# Rezoning Transportation Analysis

Petition Number: 2023-088

Date	Description
07-26-23	First Review (PM)
08-24-23	Second Review (NK)

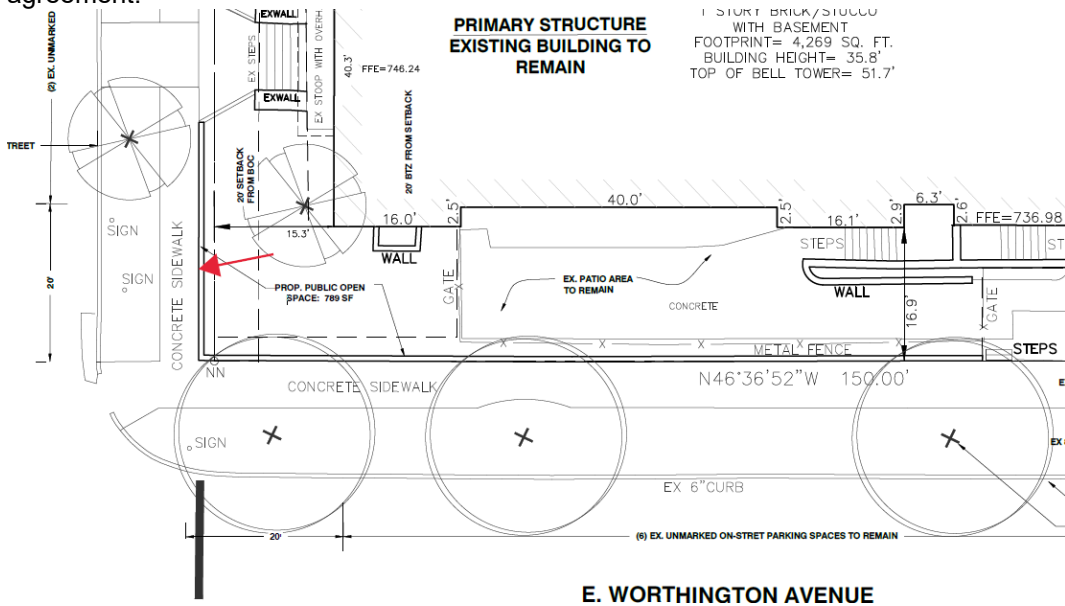
### 1. Outstanding Issue 7/26/23 Curblines:

- a. **Cleveland Avenue:** The future location of curb and gutter is to be located at 20.5ft per CLDM U-05 series for local commercial wide street typical section.
- b. **Worthington Avenue:** The future location of curb and gutter is to be located at 20.5ft per CLDM U-05 series for local commercial wide street typical section.

Label and dimension the future back of curb location from the centerline for each road on the site plan.

**Clarifying Comment 8/24/23:** Cleveland and Worthington Avenues are both shown as 30' wide streets on current site plans. These streets must be at least 41' wide from back of curb to

back of curb per CLDM U-05. Additionally, each road must label and dimension future back of curb location to the centerline.
